SECTION: 417

Service Action: Left-Hand and Right-Hand Rear Lamps LED Failure

XF (X250)

VIN: R00001 - R61290
Model Year: 2009 - 2010

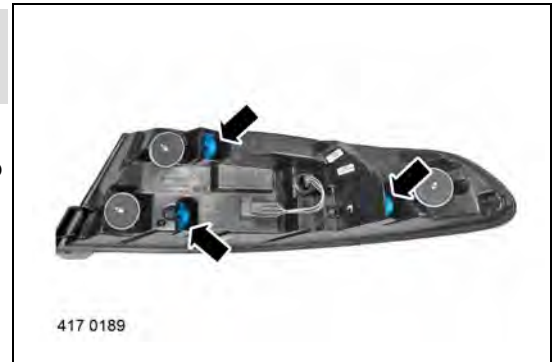
1. Turn the exterior lights 'ON'.
 - If the left-hand (LH) lamp assembly LEDs are functioning correctly, perform steps 2-4 and 6 below only.
 - If the LH rear lamp assembly LEDs are not functioning correctly, perform steps 5-6 below only.
2. Refer to Workshop Manual, section 417-01: *Exterior Lighting*, and remove the LH rear lamp assembly.

△ **NOTE: Lamps not being replaced must have the vent tubes replaced. New vent tubes are of a different material specification.**

3. Replace the vent tubes:
 - Release and remove the three (3) vent tubes from the lamp assembly.
 - Install three (3) new vent tubes to the lamp assembly.
